CITY OF ALBUQUERQUE

RE: **Lot 3 Block 10 S.A.D. 227 Unit 5**
8001 Marigold NW
Grading and Drainage Plan
Engineers Stamp Date 3/26/2021 (E10D104)

8001 MARI GOLD	DRAWN BY WCVJ
	GRADING AND DRAINAGE PLAN	DATE 3-24-21
3/26/21		210210033-LAYOUT-3-24-21
DAVID SOULE P.E. #14522	Rio Grande Engineering 1606 CENTRAL AVENUE SE SUITE 201 ALBUQUERQUE, NM 87106 (505) 972-0998	SHEET #
		JOB # 21021033

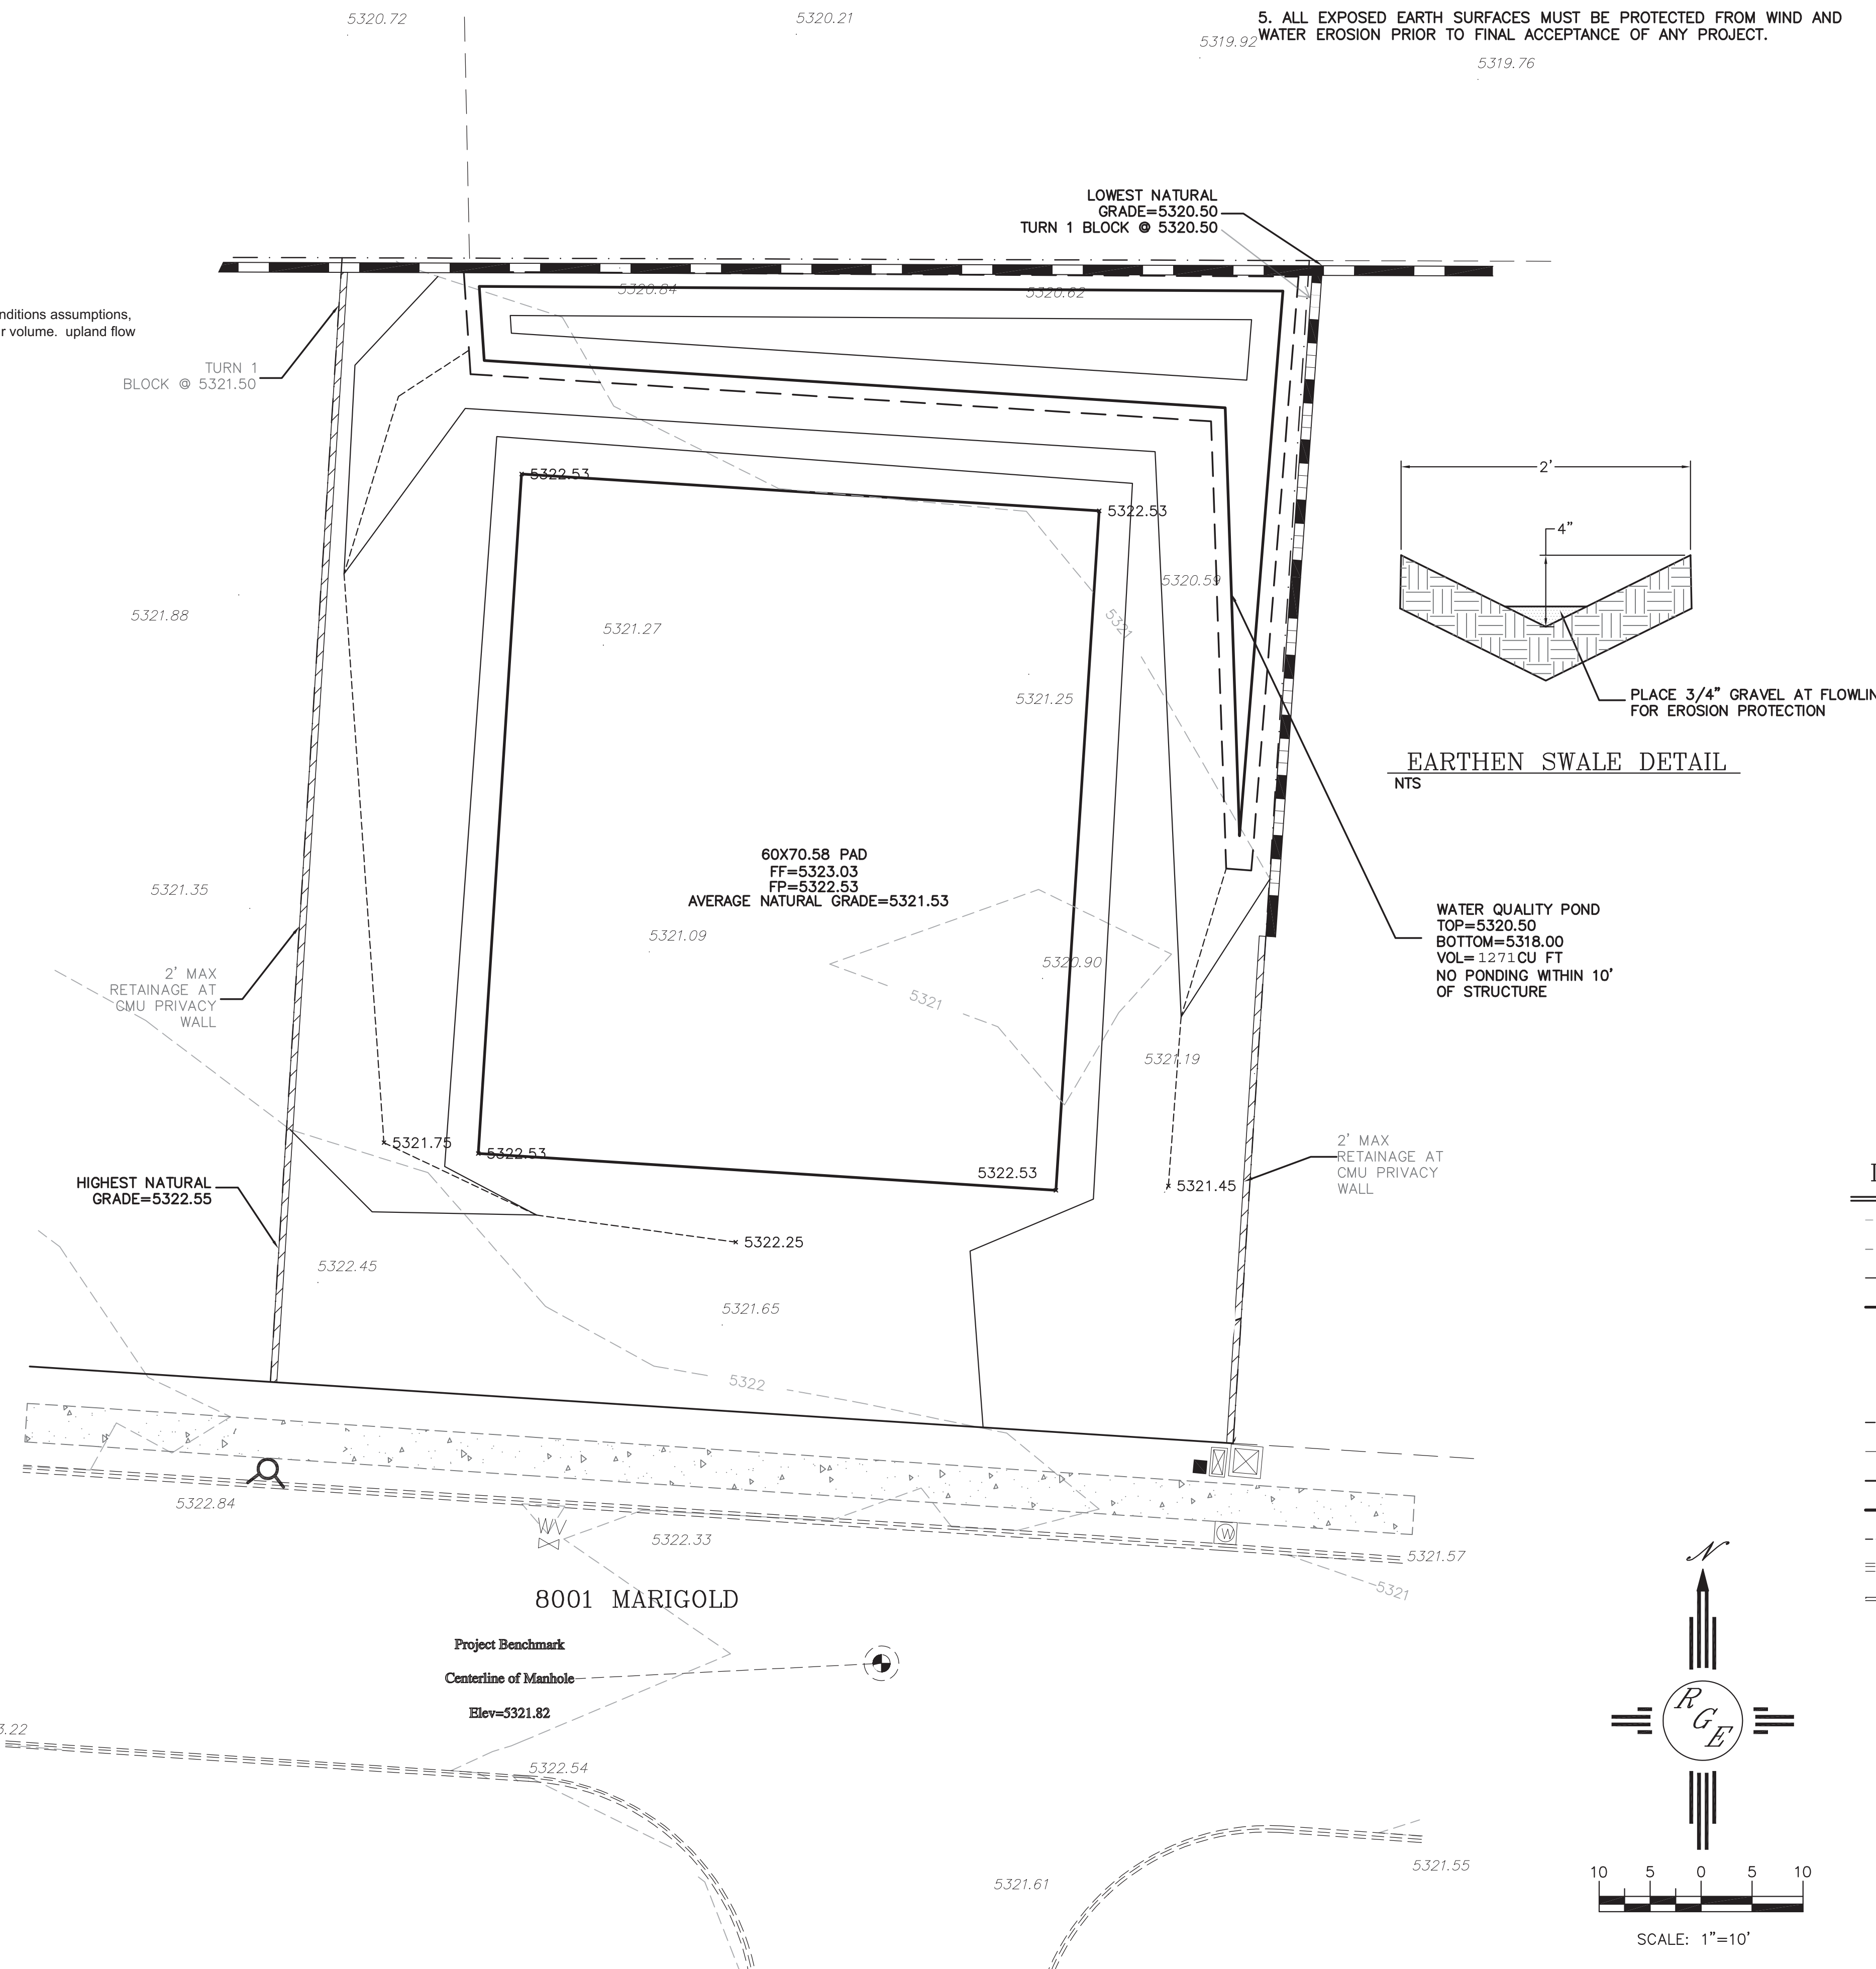
Based upon the information provided in your submittal received 3/29/2021, this plan is approved for Grading Permit. Please inform the builder/owner to attach a copy of this approved plan and letter into the construction sets in the permitting process prior to sign-off by Hydrology.

Reiterate to the Owner/Contractor that a separate permit for any garden/retaining wall must be obtained, with the approved G&D plan. Advise the owner contractor not to use dirt as a ramp to climb the curb, use lumber or crusher fines for this purpose. Also, let the owner/contractor know that if a pool is to be added in the future the G&D plan will need to be modified showing the location of the pool and the land treatment differences.

Prior to Building Permit approval, a **Pad Certification** will be required. Inform the contractor/owner not to pile dirt in the street as a ramp to climb the curb. If dirt is found in the street the pad cert. will be denied.

Prior to **Certificate of Occupancy release**, Engineer Certification per the DPM checklist of this plan will be required.
